**PLANNING COMMISSION AGENDA
APRIL 20, 2023 – 6:30 P.M.**

**PUD Amendment – Lot 2 Woodhouse Place and
Lots 1 & 2 Woodhouse Place Replat 2 – Woodhouse
Auto Family**

**CITY OF LA VISTA
PLANNING DIVISION
RECOMMENDATION REPORT**

RE: Planned Unit Development Amendment – Initial Review Letter
Lot 2 Woodhouse Place and Lots 1 and 2 Woodhouse Place Replat 1

EXHIBIT B

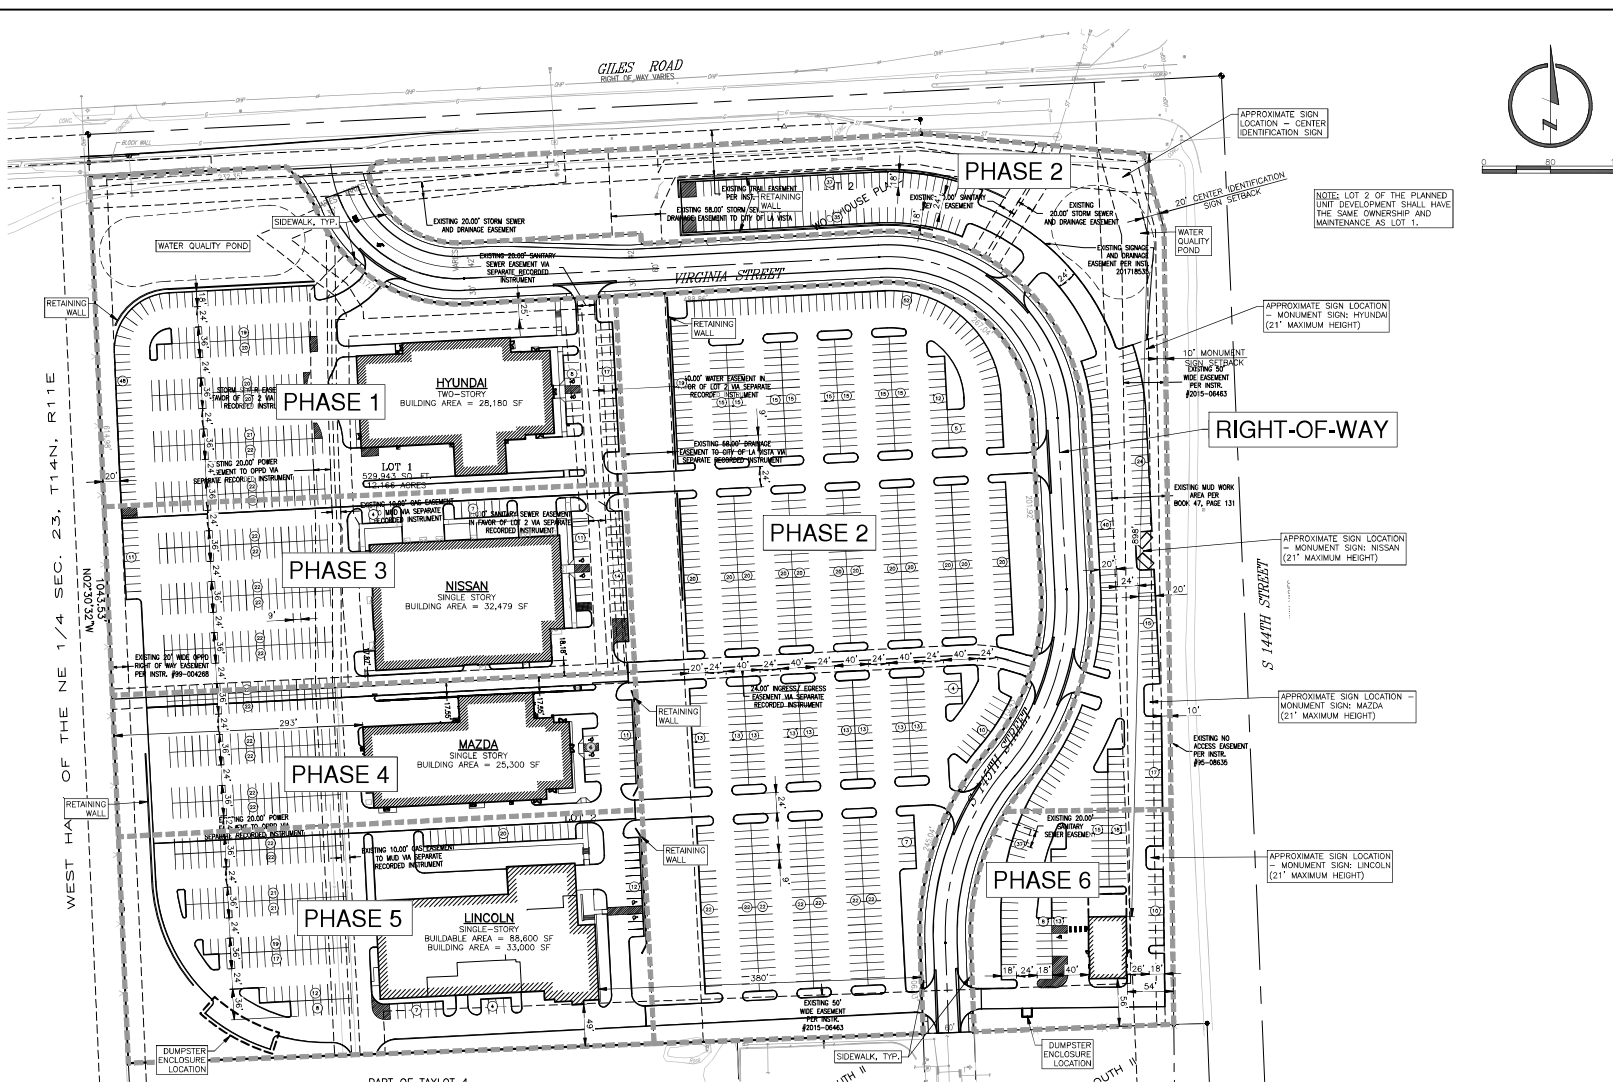
1. Please submit an updated schedule of construction, per the requirements of Section 5.15.04.01.
2. In relation to Section 5.15.04.03, please submit all applicable easements and covenants with neighboring property owners, if applicable.
3. In relation to Section 5.15.05.04, please show the point of connection and other pertinent design information for the sanitary sewer.

Please show the means of stormwater conveyance for the proposed project. The locations of any existing and/or proposed drainageways should also be provided (Section 5.15.05.02 (10)).

4. As per Section 5.15.05.02 (1), please emphasize the area of disturbance and confirm that there will be no substantial increase of impervious surface, or significant changes to the drainage pattern due to the project. Dependent upon changes in drainage pattern and/or impervious area, the existing Post Construction Stormwater Management Plan (PCSMP) for this site may need to be modified in order to account for the proposed surface drainage.

5. As per Section 5.15.05.02 (5), widths of existing right-of-ways need to be displayed.
6. Per Section 5.15.05.05 a legal description needs to be provided on the PUD Site Plan. The legal description provided needs to be updated to the current legal description for the three (3) lots involved in the PUD Site Plan.

6. As per Section 5.15.05.02 (1), please emphasize the area of disturbance and confirm that there will be no substantial increase of impervious surface, or significant changes to the drainage pattern due to the project. Dependent upon changes in drainage pattern and/or impervious area, the existing Post Construction Stormwater Management Plan (PCSMP) for this site may need to be modified in order to account for the proposed surface drainage.

7. As per Section 5.15.05.02 (5), widths of existing right-of-ways need to be displayed.

8. Per Section 5.15.05.05 a legal description needs to be provided on the PUD Site Plan. The legal description provided needs to be updated to the current legal description for the three (3) lots involved in the PUD Site Plan.

RESPONSE: An updated schedule of construction has been included on the PUD Site Plan exhibit. The schedule of construction is listed here as well.

RESPONSE: The updated PUD site plan includes all easements within the project limits.

RESPONSE: The area of disturbance for Phase 6 is indicated on the PUD site plan. No substantial increase of impervious surface or modification of the existing drainage pattern is anticipated.

RESPONSE: All right-of-way widths are shown on the updated PUD site plan.

RESPONSE: The legal description has been updated as indicated.

PLANNED UNIT DEVELOPMENT
GRADING PLAN

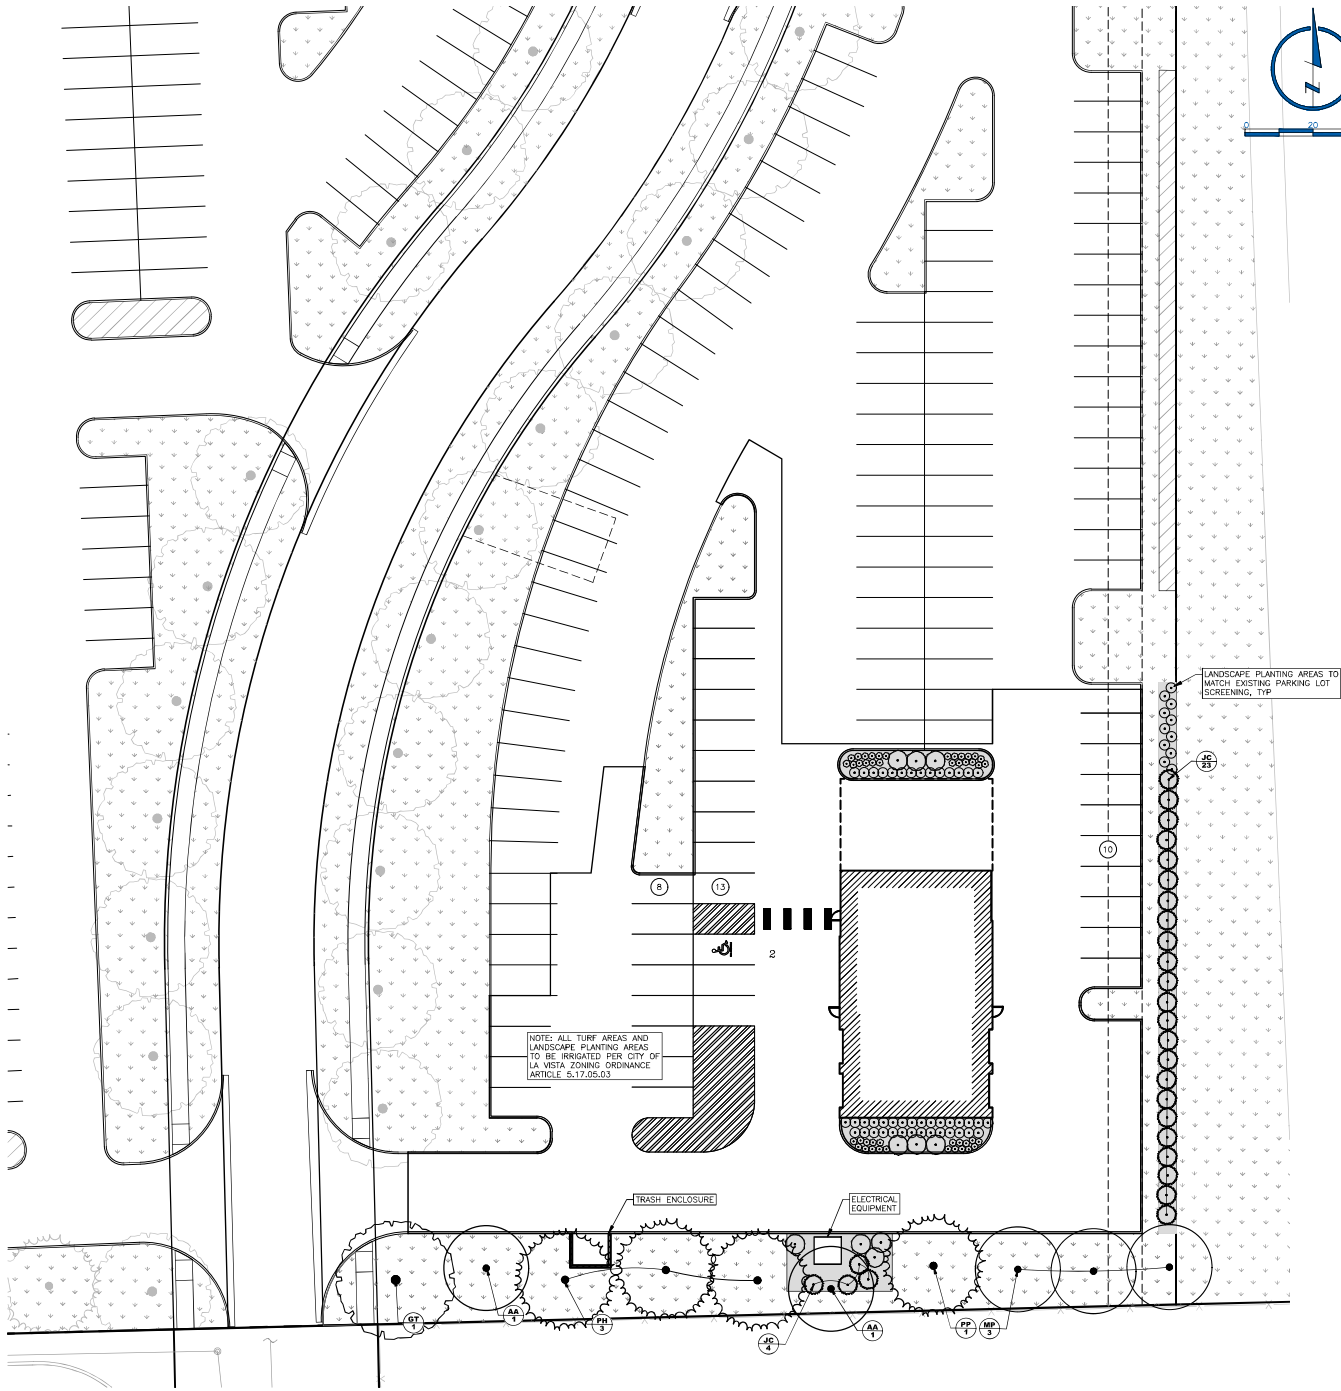
4. Please show the means of stormwater conveyance for the proposed project. The locations of any existing and/or proposed drainageways should also be provided (Section 5.15.05.02 (10)).

RESPONSE: A utility plan and grading plan have been provided illustrating the schematic storm sewer layout and drainageways.
